ORIGINATION FORM

Proposed Revisions to a Standard Plans Index
(Please provide all information — Incomplete forms will be returned)

Index Number: 455-003
Sheet Number (s): 1
Index Title: Square Prestressed Concrete Piles-EDC
Instrumentation

ELEVATION

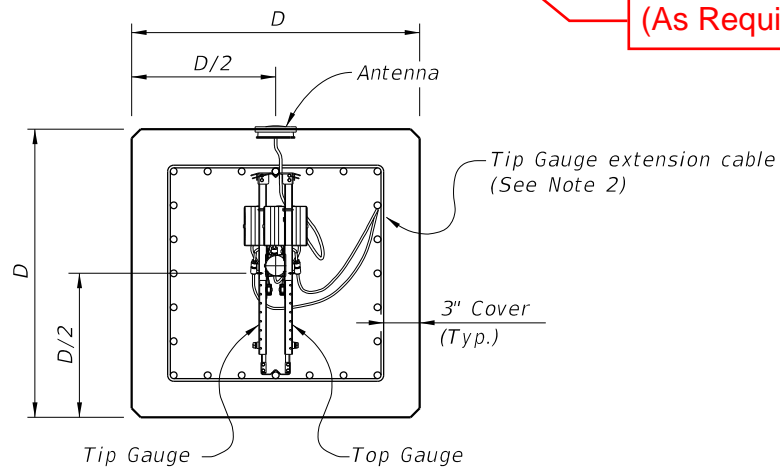
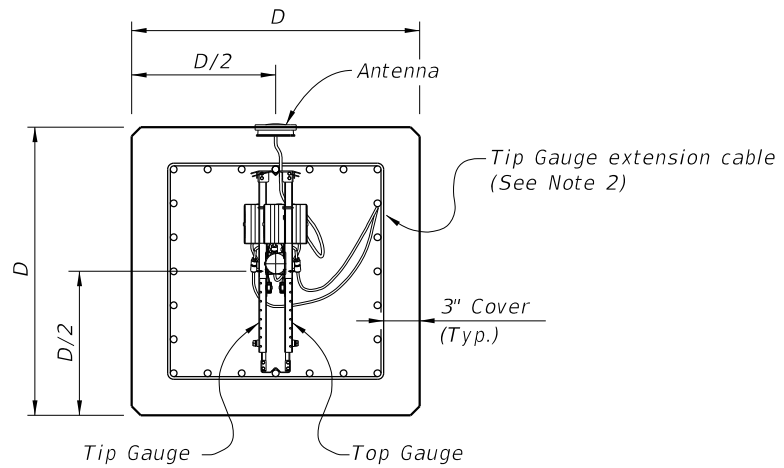
Deleted notes 3 & 4, and changed reference.

Discussion since the Interim was posted decision that the notes were not appropriate for the Standard, so the reference is now to see the plans for requirements.

1. For piles 18" and larger installed for bridge foundations, provide EDC Instrumentation in accordance with Specification Section 455.
2. Attach Tip Gauge extension cable to the underside of the strand shown in Section A-A. Secure cable to strand with nylon wire ties spaced a maximum of 6ft. along cable.
- ~~3. Tip Gauge required in all EDC test piles.~~
- ~~4. Tip Gauge required in at least 10% of EDC Piles in all Bents and Footings.~~

1. For piles 18" and larger installed for bridge foundations, provide EDC Instrumentation in accordance with Specification Section 455.
2. Attach Tip Gauge extension cable to the underside of the strand shown in Section A-A. Secure cable to strand with nylon wire ties spaced a maximum of 6ft. along cable.
